**Question 1: Was Whole Foods footprint remediated when it was built?**

**Follow up to question #1:**

**Below, New York City Tax Map of the block:**

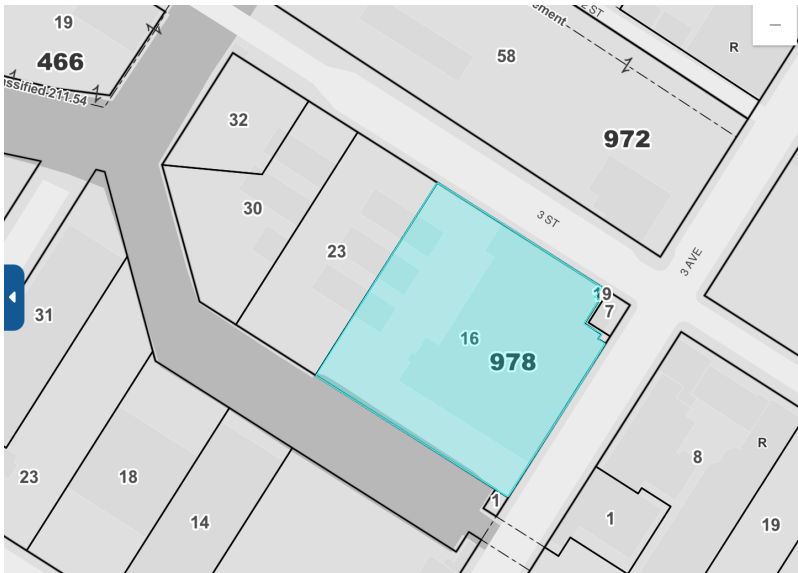
**It appears that the area of the parking lot that was owned by The Crushers was not entered under the Brownfields Program. Attached is the easement document the NYSDEC placed on the property following the BCP work. It covers the lots 16-1 on block 978, *but not lots 23, 30, or 32. There is no evidence that Lots 23,30,32 were ever in the DEC Brownfield Cleanup Program.***

**As far as our committee members recall, the cleanup work on Lots 1-16 was for the removal of septic tanks on the site. Was testing done for other contaminants? If so: Which ones? What were the results? Was the site remediated for such contaminants?**

**Thus, our question regarding recontamination stands.**
